Didsbury Point

Non Material Amendments

Project name: Didsbury Point
Project number: 8845
Client: Southway Devco

Following recent approval of the Section 73. submission this document aims to pick up all remaining non material amendments made to the consented residential development; Didsbury Point (planning application ref. 135235/FO/2022), during the design development stage.

Updated Podium Layout Design

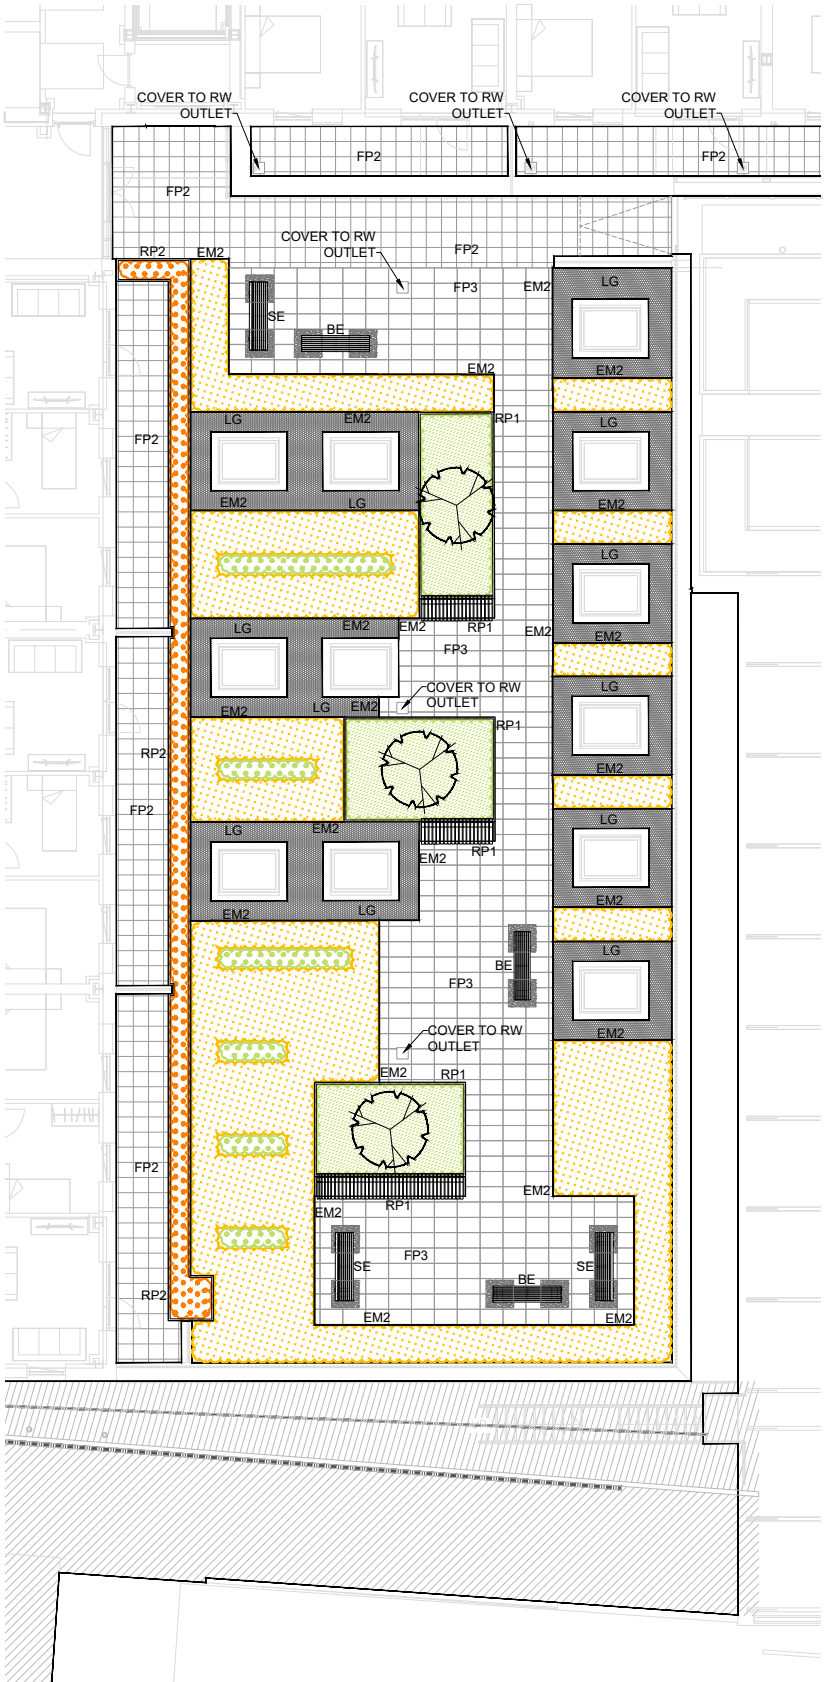
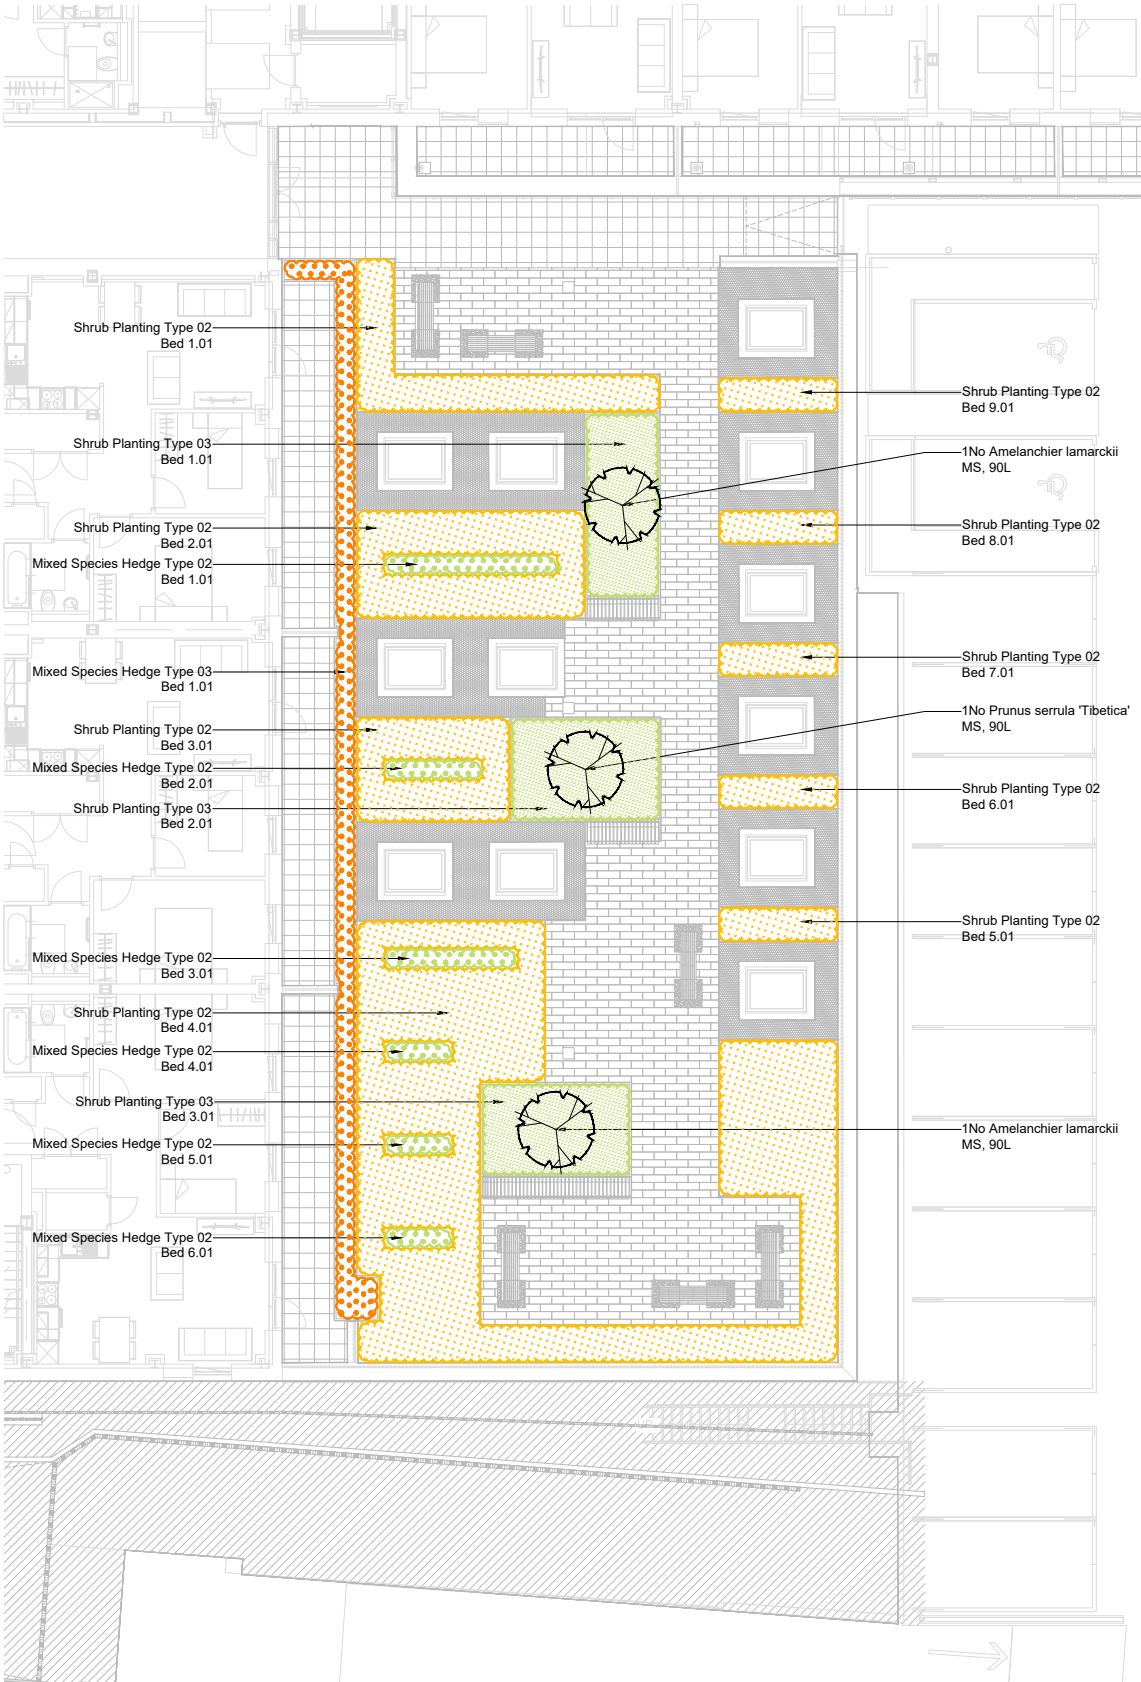
The updated podium layout has been subject to a number of design changes due, in the main to technical requirements regarding fire spread related to build up and area limitations.

The gro roof guidance stipulates a min. 300-500mm gravel margin (firebreak zone) around the rooflights. This reduced the area of vegetation which could be incorporated into the planting scheme. The original intent of composite timber decking was also re-specified as paving in order to align with the BRoof(t4) requirements which required a full encapsulated finish atop the membrane and insulation layers.
